### Planning Board Meeting

**June 25, 2024 - 6:30 PM**

- 4.B. Consider a recommendation on Petition #R24-01, a request by Hotel Ventures of Lake Norman Inc. to rezone +/- 10.328 acres located at 8830 Northpointe Executive Park Drive from Highway Commercial-Conditional District to Highway Commercial-Conditional District for a 3-story hotel development.

- 4.C. Consider a recommendation on Petition SUP24-01, a request by Hotel Ventures of Lake Norman Inc. for a Special Use Permit for +/- 10.328 acres located at 8830 Northpointe Executive Park Drive for a 3-story hotel development.

(Proposed street front view elevation with over 90% brick cladding and more street front windows)

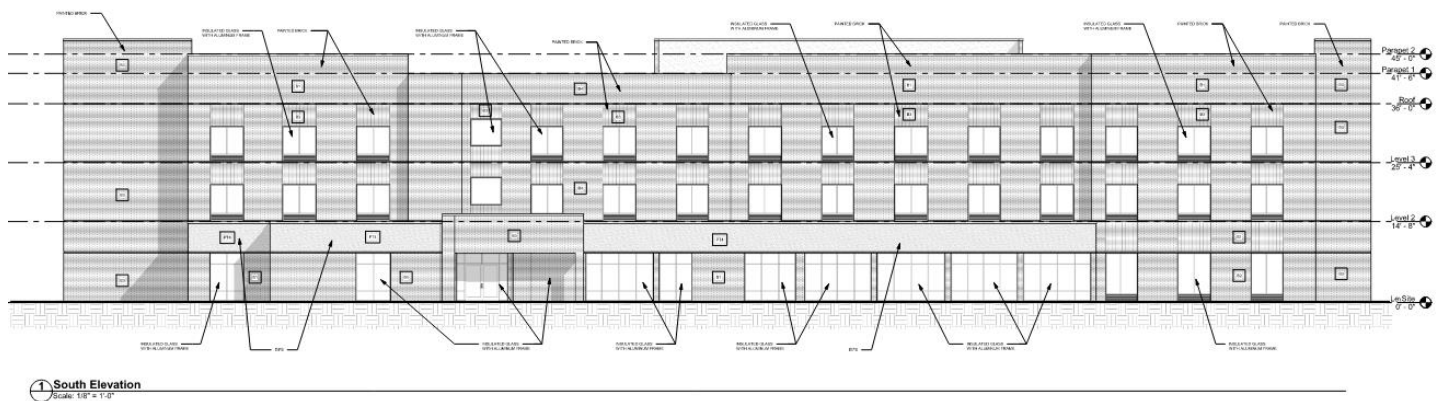
**Staff Comment:** On the first edition of the proposed building, staff reviewed and commented with concerns regarding the architecture, which was for a 4-story hotel building with 132 rooms. The massing would not likely have followed the standards above. Adjacent property owners also voiced their concerns regarding the height and view of the structure in relation to their homes (as seen in the Community Meeting Reports). The current proposal, in response reduces the height to 3-stories with 121 rooms. Staff still had concerns with the version of the plans submitted for the Public Hearing regarding the architecture of the building as it related to the building materials (mostly EIFS) and the compatibility to the materials in the office park. The office park is comprised of brick clad buildings of 2 and 3 stories.

**Update:** The most updated version of the elevation plans proposed meet staff's expectations as they relate to the office park and zoning ordinance requirements listed above. It is worth noting that the 3<sup>rd</sup> floor windows to the rear of the building, facing the single family residents are still in place (see attached elevations), which were a concern at the community meetings as well as with the Cornelius Planning Department.

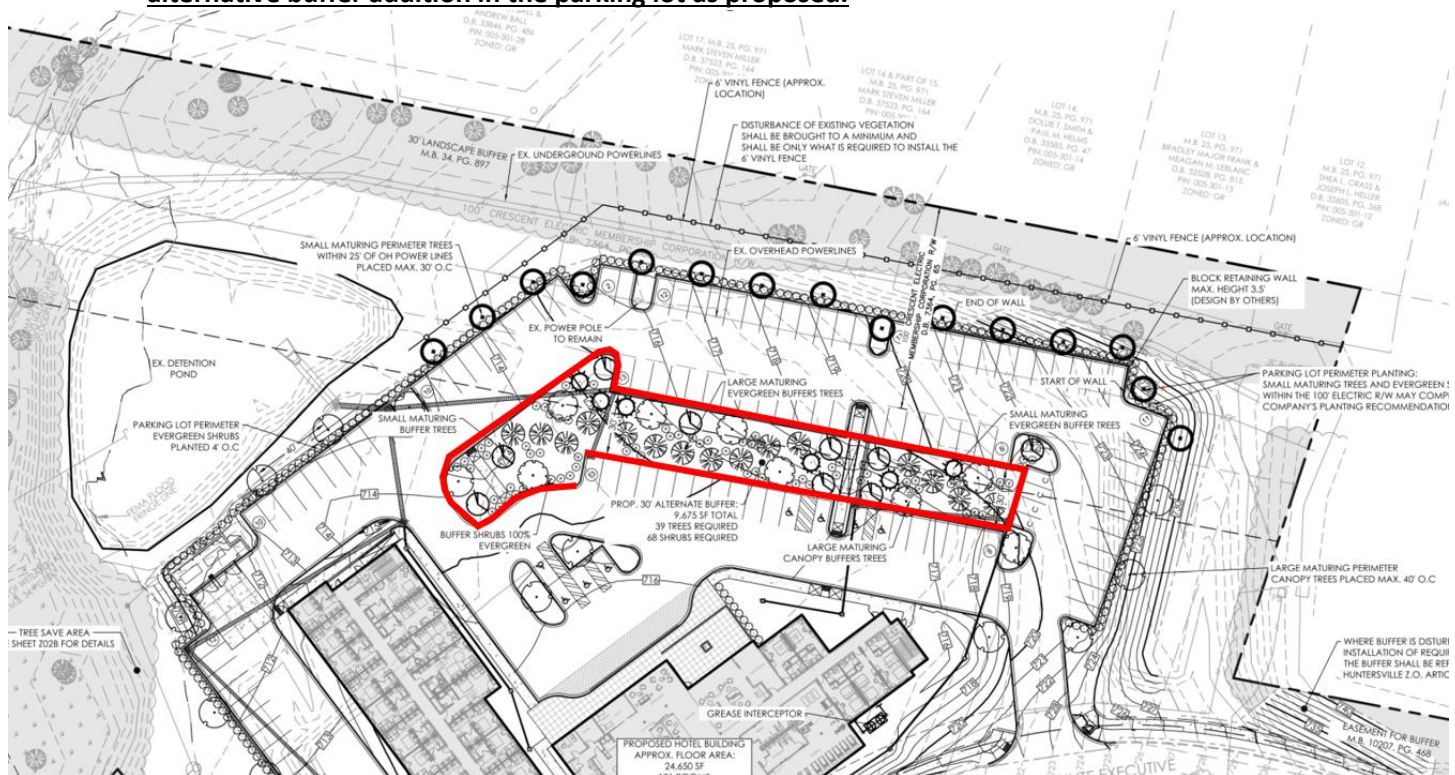
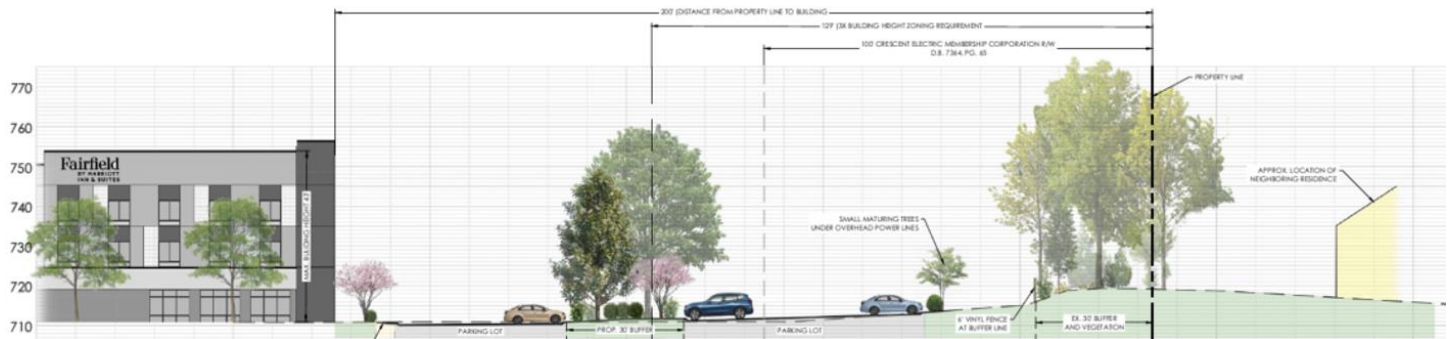
- Article 7.5: Requires a 30-foot undisturbed buffer abutting the single-family properties to the north. Due to an existing 100' Energy United Right-Of-Way that starts at the north property line and extend 100' into the subject property, the proposal cannot guarantee the 30' buffer can remain undisturbed with the energy company's rights to maintain as needed. The existing buffer within the energy ROW does have some existing vegetation present and a proposed 6-foot in height vinyl fence.

**Staff Comment:** Article 7.5.7 and 7.5.9 allows an alternative buffer in situations like these. Due to the energy ROW being within the required buffer area, the applicants have shown a 30' buffer internal to the site (seen below). This buffer is within the parking area and is in a 30-foot wide planting area with a mix of large deciduous and large evergreen trees, some small maturing trees and shrubs that will buffer vehicular lights. The **Modification Request** is to have the ability to use some of the area between the 30' undisturbed buffer (not guaranteed to remain) and the alternative buffer, as parking area. **Staff is in support of this modification request as 1) there is reasonable separation of uses (60-foot distance between parking lot and single family residences) and 2)adequate screening of the parking lot(shrubs planted every 3-feet on center and small trees planted every 30-feet on center, per code requirements) as well as 3) the previously described existing vegetation 4) proposed fence 5) alternative buffer addition in the parking lot as proposed.**

## Changes Based on Community Feedback

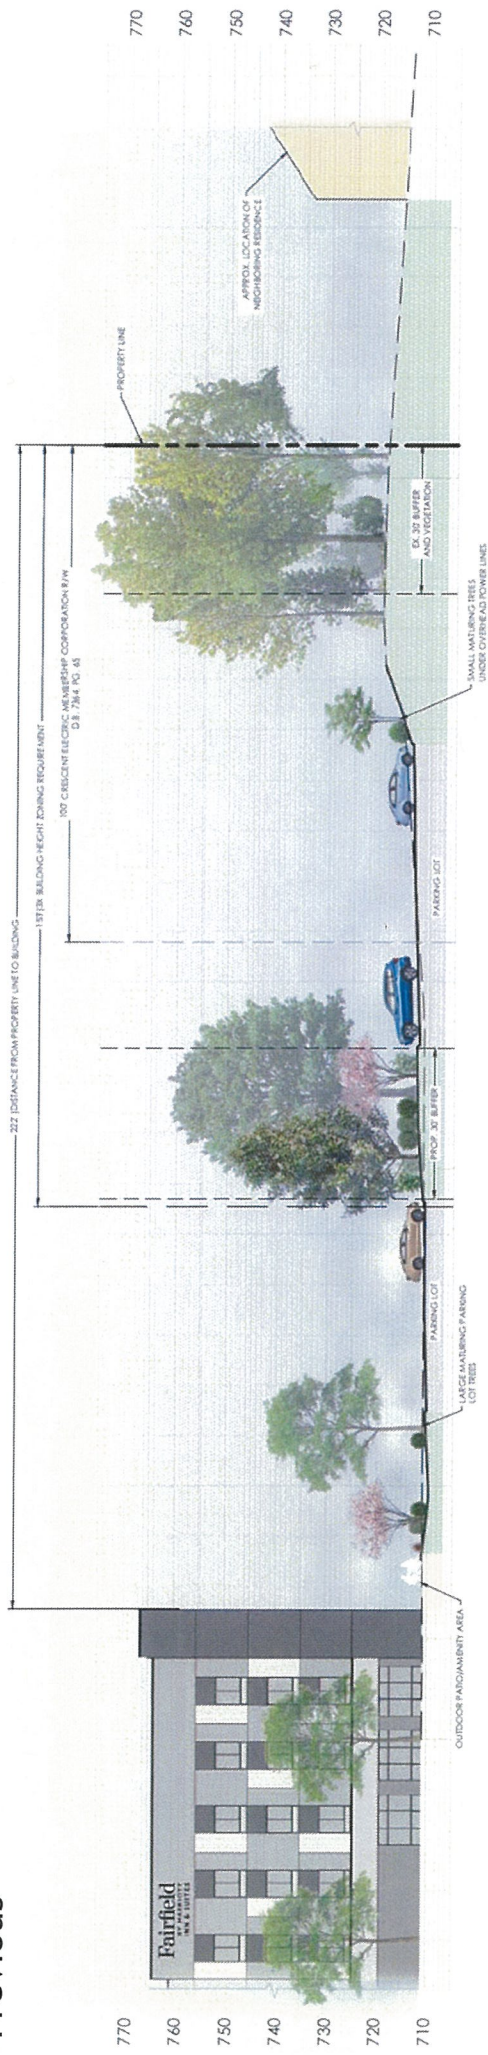
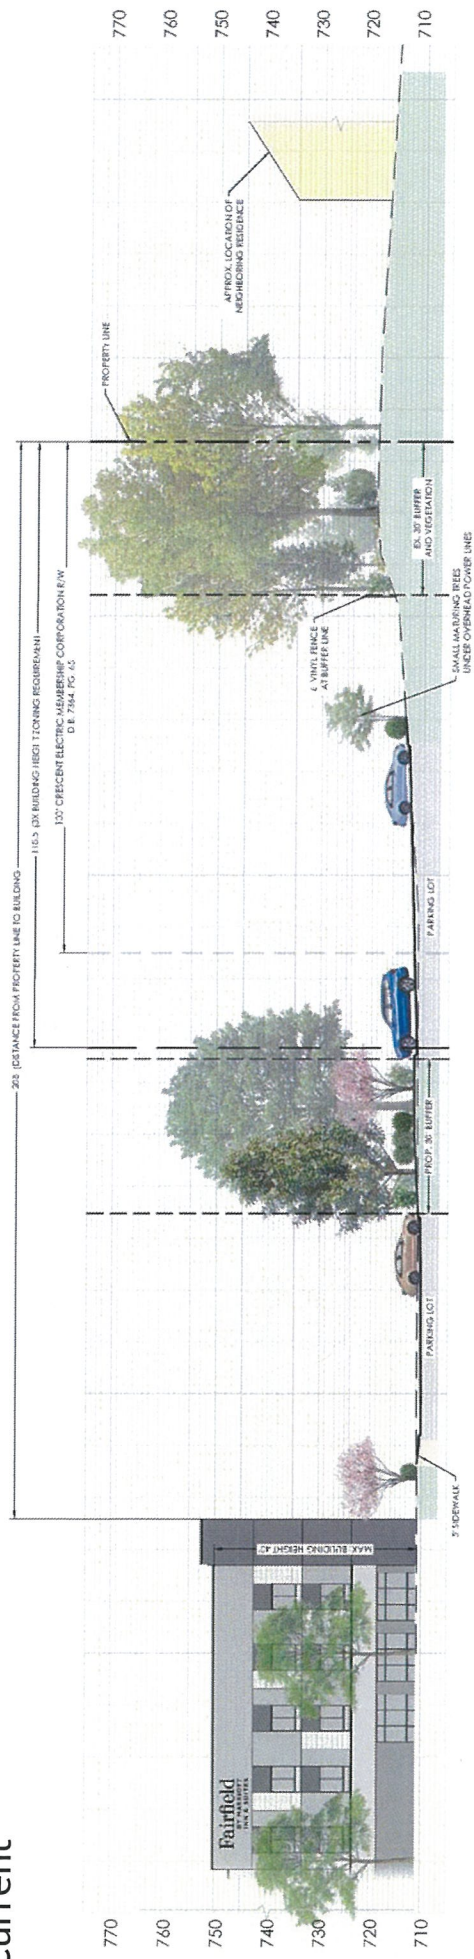
- ▶ Reduced height of building from four stories to three.
- ▶ Six-foot fence added to existing vegetated area.
